<b>AMENDMENT OF SOLICITATION/MODIFICATION OF CONTRACT</b>			1. Contract Number	Page of Pages 1   1
2. Amendment/Modification Number DCAM-2008-B-0014-001	3. Effective Date 11/14/2007	4. Requisition/Purchase Request No.	5. Solicitation Caption Eastern Market Rehabilitation

**ADDENDA NO. 1****EASTERN MARKET REHABILITATION**

IFB No. DCAM-2008-B-0014  
 225 7<sup>th</sup> Street SE  
 Washington, DC

**THE DOCUMENTS DATED 19 SEPTEMBER 2007 SHALL BE AMENDED AS FOLLOWS:**

PROJECT NO. EA710B
BLDG ID NO. 47
DATE: 14 NOV 2007
DRAWING NUMBER
<b>2/E122</b>

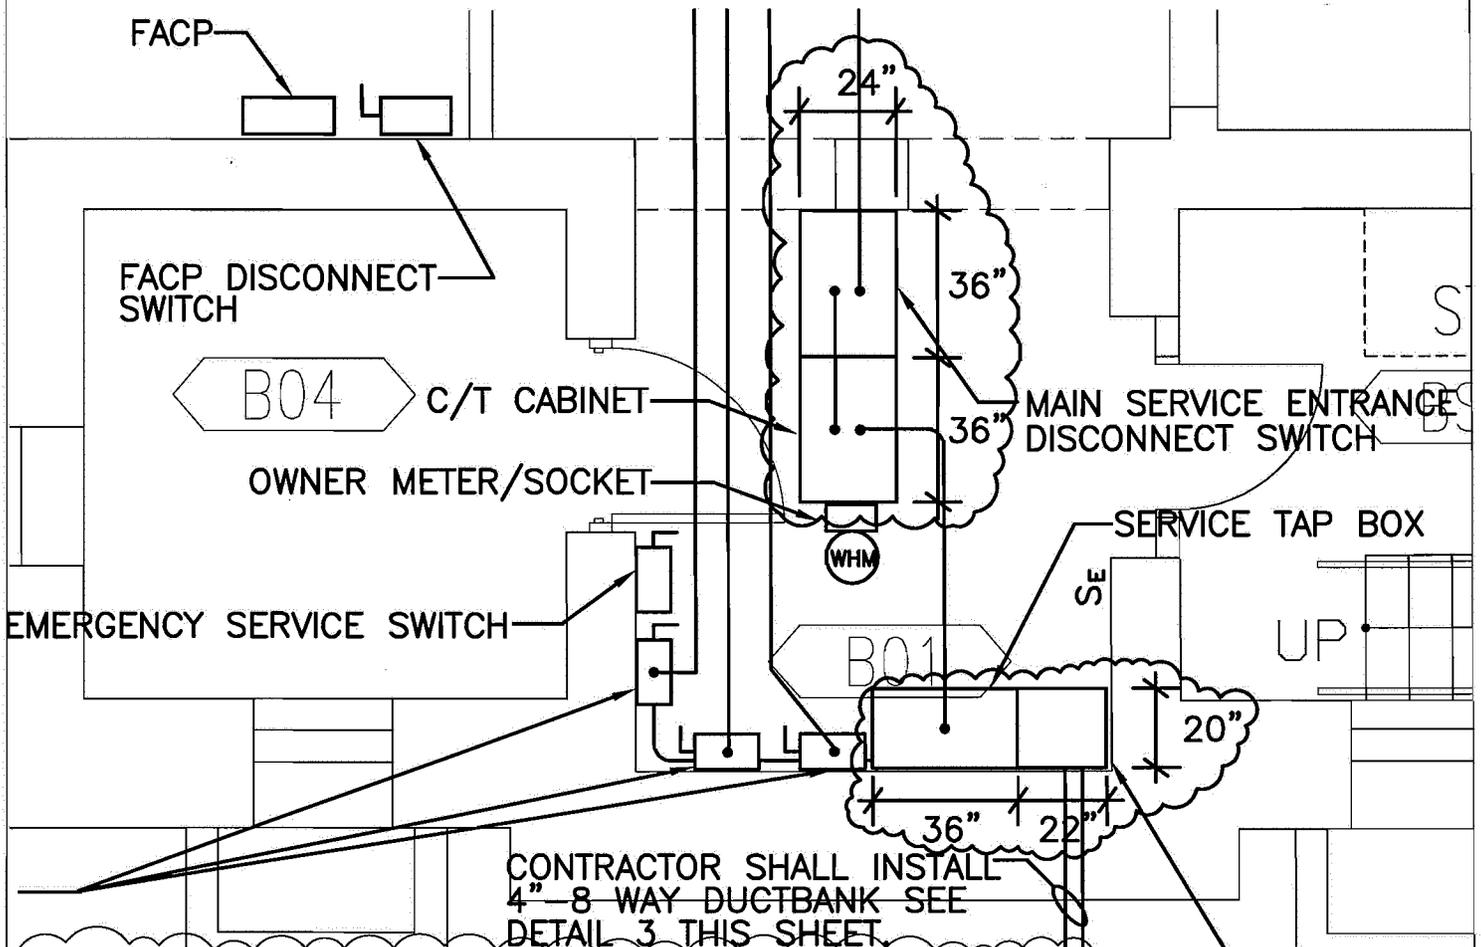
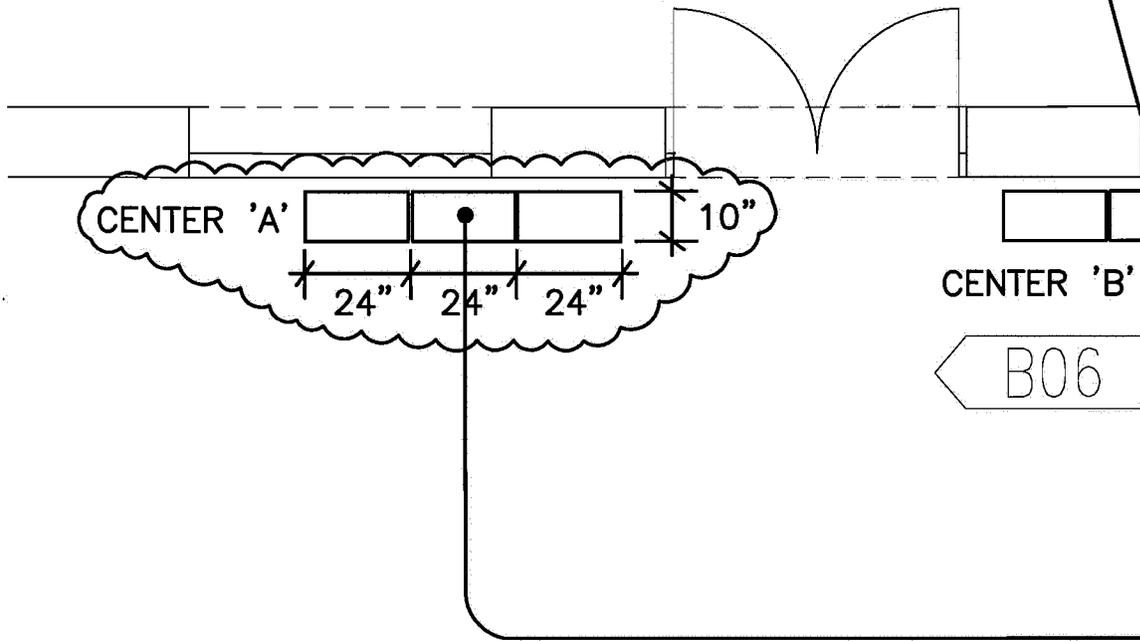
Sheet No.	Change:
E122	<u>Revise</u> drawing 1 to provide a special receptacle and to revise the new kiln transformer requirements at Room B09 per <b>attached detail 1/E122, dated 14 Nov 2007.</b>
E122	<u>Revise</u> drawing 2 to put emergency lighting on emergency circuit per <b>attached detail 2/E122, dated 14 Nov 2007.</b>
E601	<u>Revise</u> drawing 1 to include layout dimensions for new power distribution equipment per <b>attached detail 1/E601, dated 14 Nov 2007.</b>
E602	<u>Revise</u> drawing 2 "New Power Riser Diagram", as described below and per <b>attached detail 2/E602, dated 14 Nov 2007.</b> <ol style="list-style-type: none"> <li>1. At grid locations D8 and F9, to provide feeder and conduit size.</li> <li>2. At grid location D13, to omit the FACP disconnect switch.</li> <li>3. At grid location J11, to provide requirements for panel 'MDP2'.</li> </ol>
FA103	<u>Add</u> drawing "Fire Alarm Annunciator Panel" per <b>attached detail FA103, dated 14 Nov 2007.</b>
